4727 12th Avenue NE
APN: 674670-1970
Zoning: SM-U 75-240 (M1)
Overlay: University District NW Urban Center Village
Lot Area: 4500 sf
Current Use: Single Family Residential

EDG RESPONSE

NORTH ELEVATION WINDOW ADJACENCY DIAGRAM

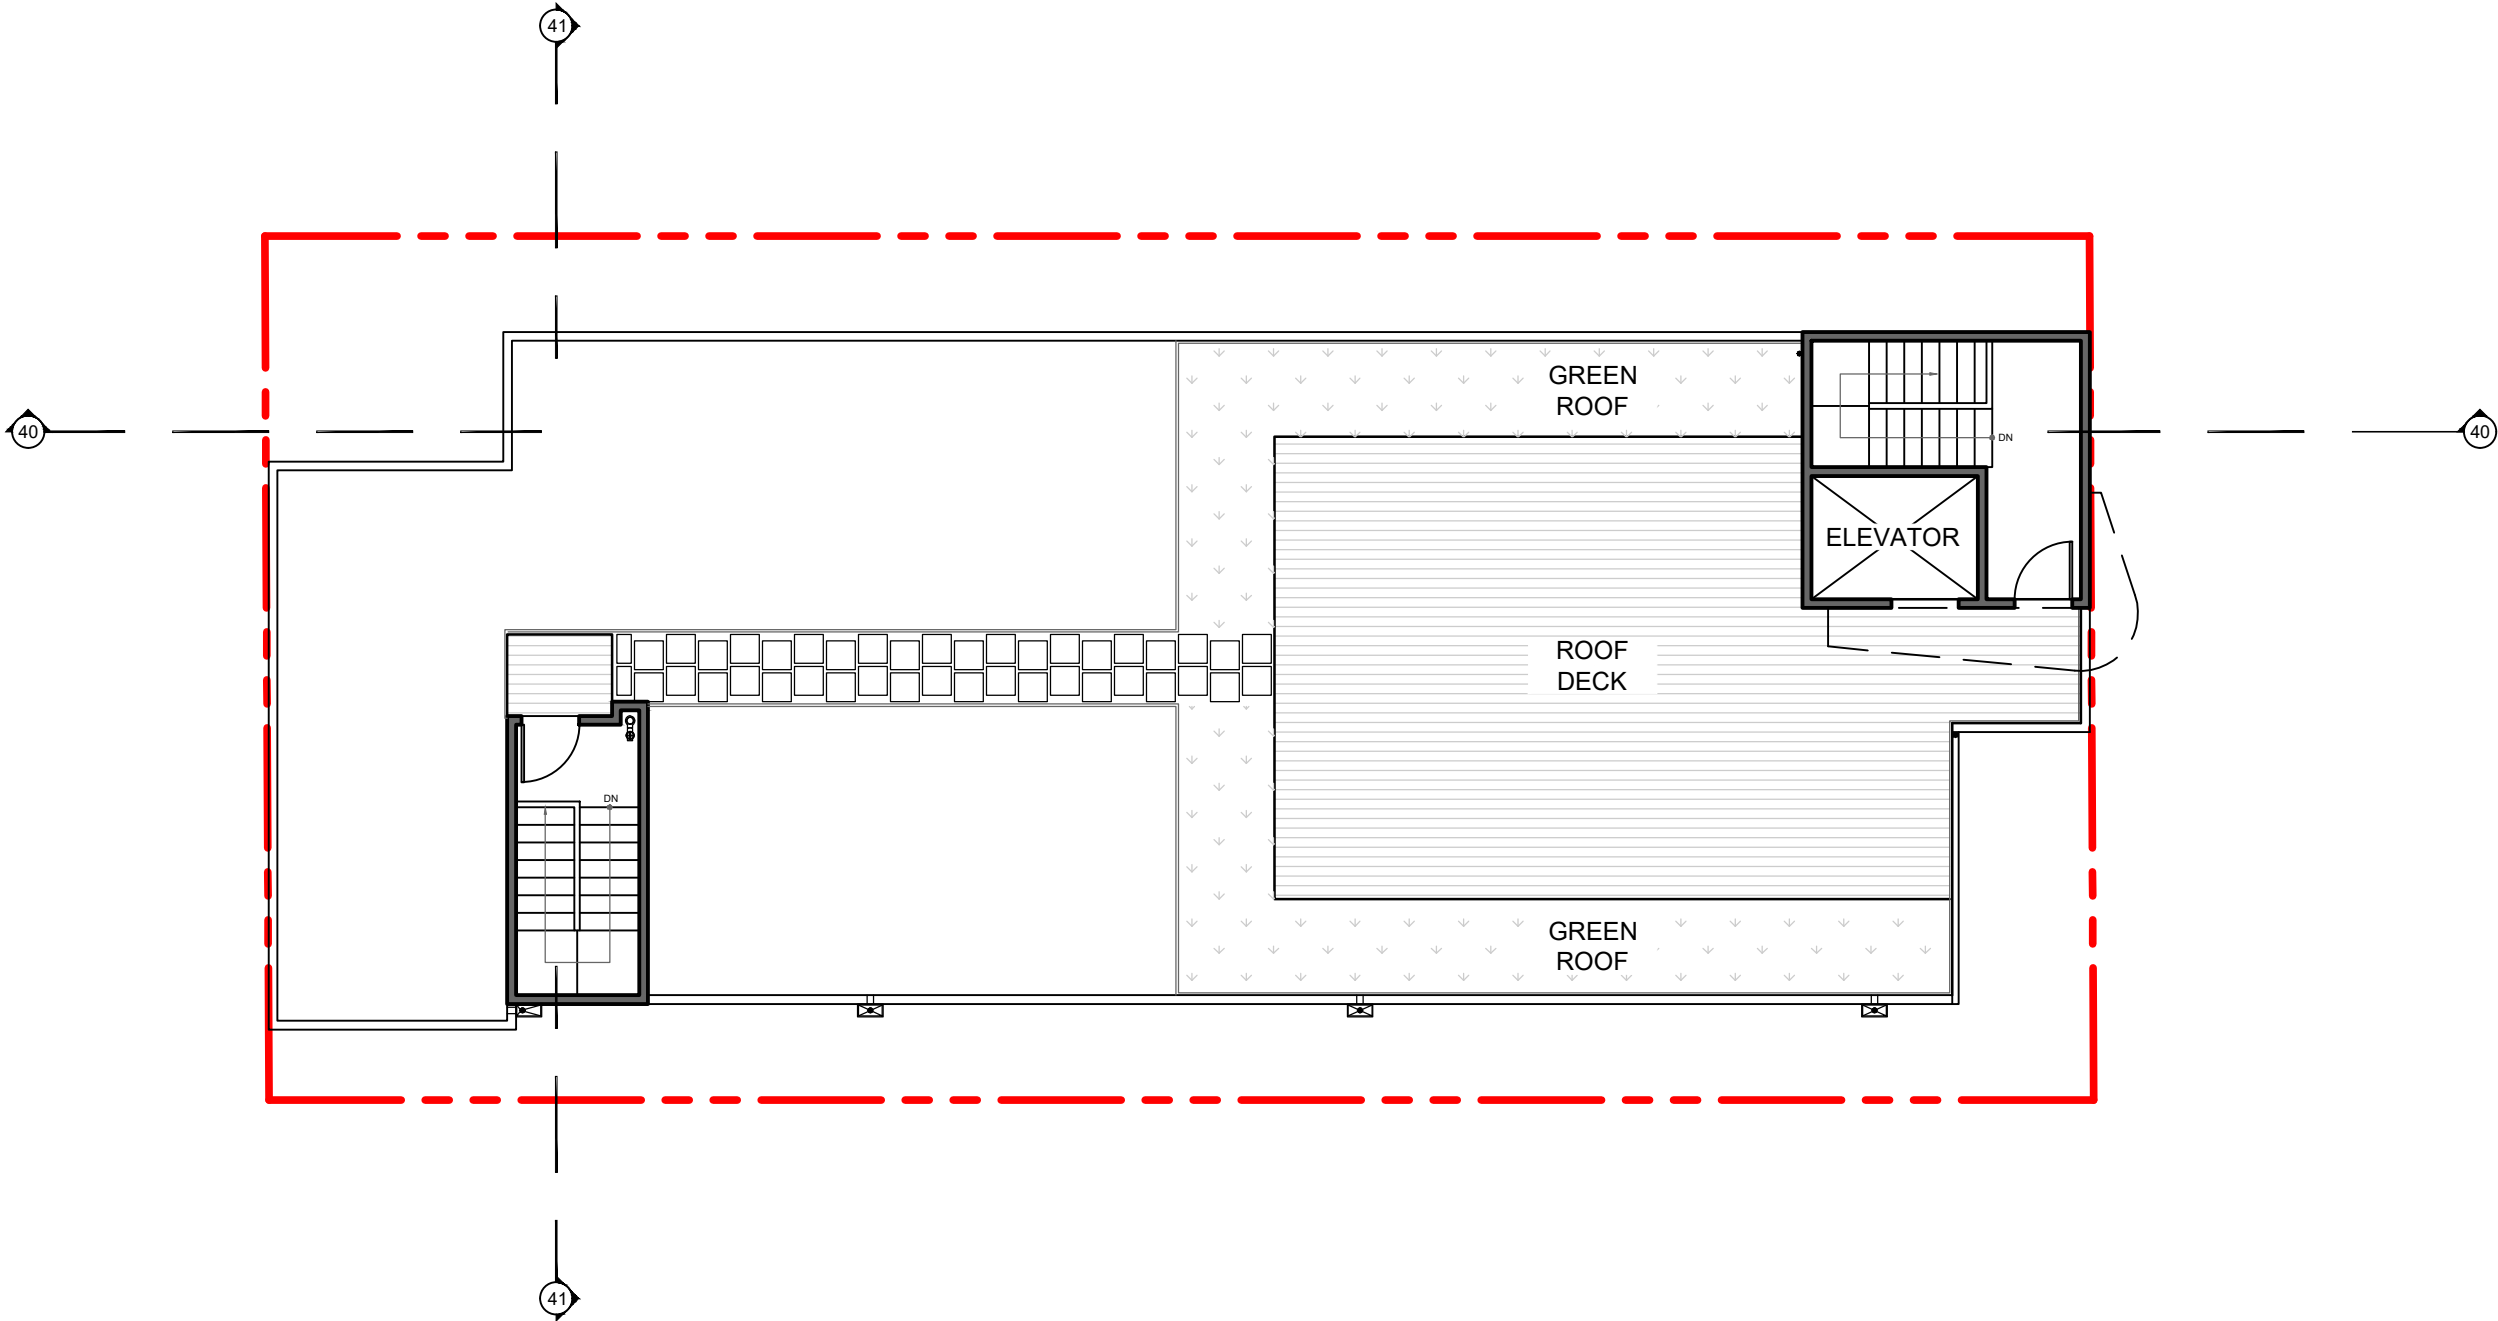
- At the EDG meeting, the following comments were provided:
- Asked if trash could be moved to the opposite side of the building.
 - Expressed concern that the ‘sunken’ walkways located along the north and south of the building designed as emergency egress for basement units will become throughways and loitering spaces for transients as they are connected directly to the alley. As such the commenter requested that gates be installed to discourage any unauthorized use of those walkway spaces.
 - The owner of the hotel expressed concerns about view impacts into their units and asked if floor level heights of the proposed structure would be the same as the motel.
 - Concerned that the building of 67 residential units without parking would be an impact and suggested that a building manager would even have a car – thus needing a place to park.

- While public concerns about the project not providing parking are not addressable, we have addressed the following items:
- The trash room was relocated to an interior enclosed room.
 - The sunken walkways will be outfitted with gates for security.
 - View impacts to adjacent buildings have been analyzed via fenestration diagrams and have been adjusted, where possible, to minimize overlap with neighboring doors and windows.
